Specific Design Plan 7-Eleven at Brandywine Village

SDP-1803

STAFF REPORT

SUBJECT: Specific Design Plan SDP-1803
 Type 2 Tree Conservation Plan TCP2-002-2014-06
 7-Eleven at Brandywine Village

Figure 1: Site Plan

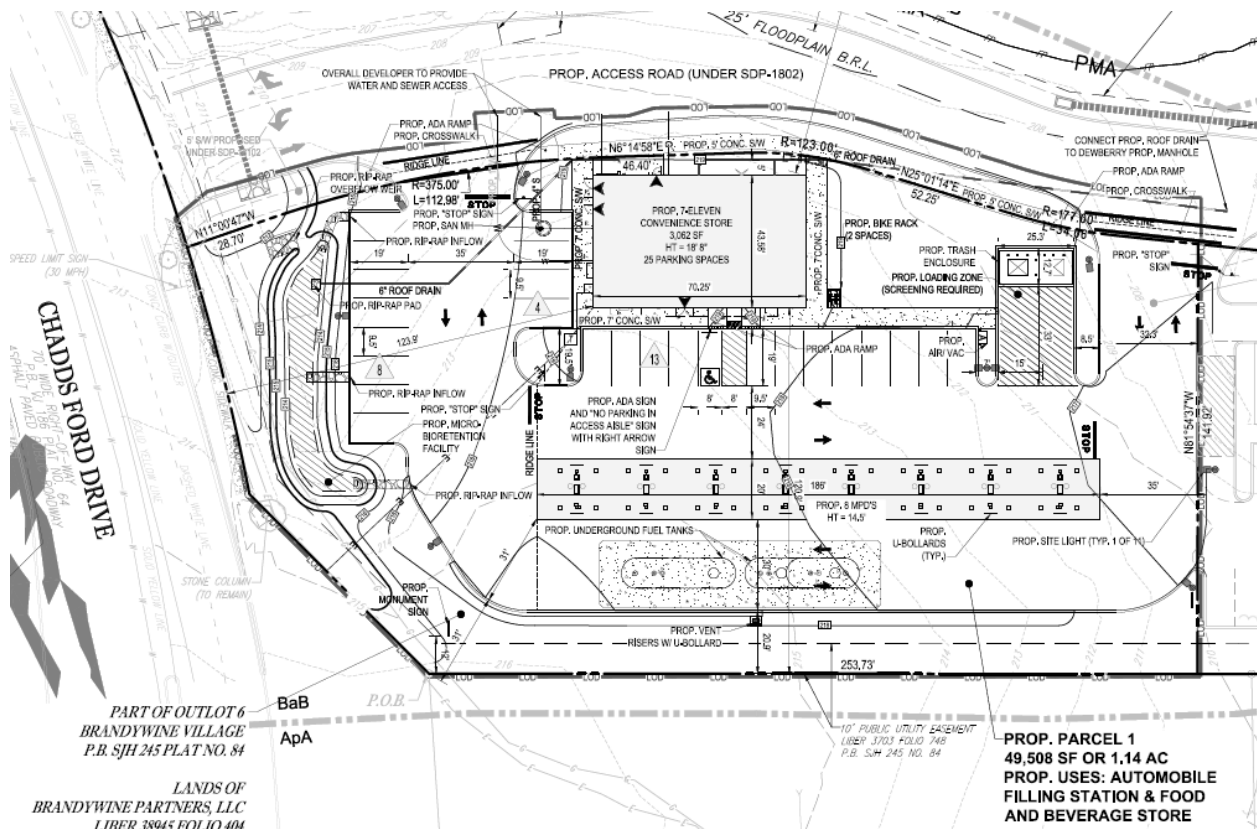
Vehicular and pedestrian access to Parcel 1 is provided through northern and southern driveways and sidewalk connections to the access road to the west. The northern driveway is shared with the proposed eating and drinking establishment on Parcel 2. The southern driveway is located within close proximity to the intersection of Chadds Ford Drive and the access road. Development proposed on Parcel 1 includes a single 3,062-square-foot building for a food and beverage store located in the west-central portion of the site, and gas station canopy with eight fuel dispensers on the east side of the site. The building and canopy are oriented with their lengths aligned parallel to US 301. A fenced trash enclosure and loading space are proposed to the north of the building. Parking is provided directly south and east of the building, and two bicycle racks are adjacent to the northeast corner of the building. Sidewalks are included around the building connecting to the sidewalk proposed on the east side of the Brandywine Village Commercial access road. The proposed single-story building is to be faced on all sides with a combination of exterior installation finish system (EIFS) panels and stone veneer, in complimentary brown and tan colors. The main entrance to the building is on its east side, with a secondary entrance on its west side. Fenestration is limited and provided primarily on the eastern façade. A smaller area of windows is provided on the western façade with the secondary entrance to the building. The gas station canopy is to be clad with the same EIFS and stone veneer as the food and beverage store.

A photometric plan provided with the SDP demonstrates that adequate exterior lighting of the site will be provided. Lighting at the northern boundary of Parcel 1 shows two pole-mounted lights on Parcel 2 to the north. One of these lights, shown adjacent to the southwest corner of the building, is not included as part of SDP-1802 for Parcel 2. The subject SDP is limited to Parcel 1 and cannot propose offsite impacts. A condition has been included in the Recommendation section, to remove this light from the plan. A comprehensive signage package is provided that includes building and canopy mounted signs, free standing directional and identity signage, and monument signage for site identity and display of fuel prices. As provided, two key modifications and minor corrections are required for the signage package to conform with the sign guidelines of CDP-1201-01. The necessary modifications include the removal of a large multi-business pylon sign, which is provided by SDP-1802, and removal of one of two monument signs shown on the site's frontage with US 301.

- 1. Prior to certificate approval of the specific design plan (SDP), the applicant shall:
 - a. Update the photometric plan to remove a pole-mounted light shown adjacent to the southeast corner of the building on Parcel 2, subject of SDP-1802.

- k. Revise the site plan to restrict egress from the southern access driveway on Parcel 1. Provide signage that prohibits egress on the site plan and a detail of the sign. This signage must be in conformance with the requirements of the Prince George's County Department of Permitting, Inspections and Enforcement.
